COUNTY OF EL DORADO

**SUBJECT: Addendum No. 4
Sawmill 1B Bike Path Project
(Contract No. 95148)**

**CONCRETE RETAINING WALL-CALTRANS TYPE 5,
H=12' FOOTING AND PILE LAYOUT
STATION 171+68.25 TO 171+88.25**

SAWMILL 1B BIKE PATH PROJECT
CONTRACT NO. 95148
ADDENDUM #4

RW-01A

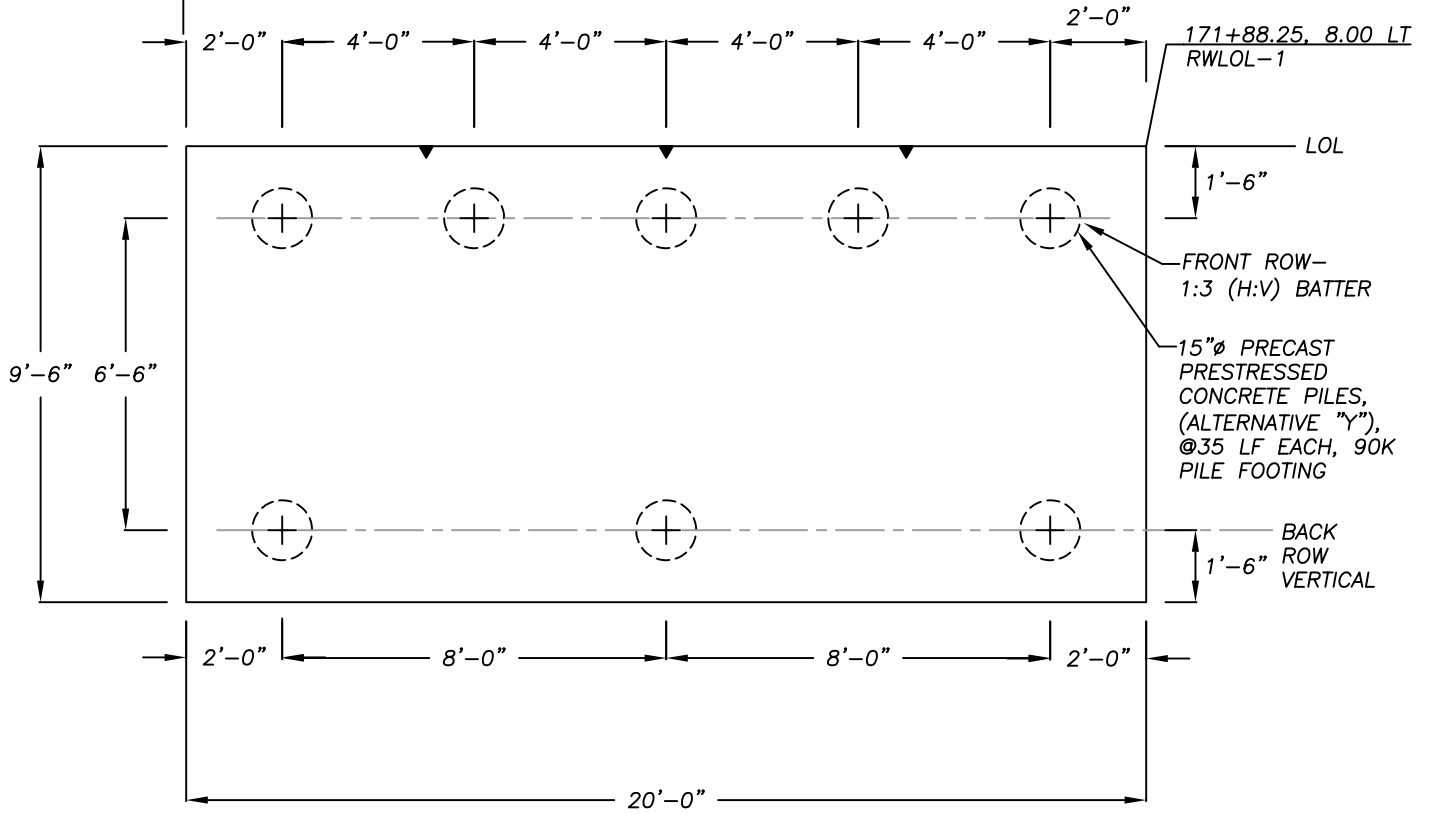
1. SEE STANDARD PLANS B3-7, B0-3, AND B3-8 FOR DETAILS NOT SHOWN.

2. SEE STANDARD PLAN B2-5 FOR PRESTRESSED 15" CONCRETE PRECAST PILES, CLASS 90, ALTERNATIVE "Y"
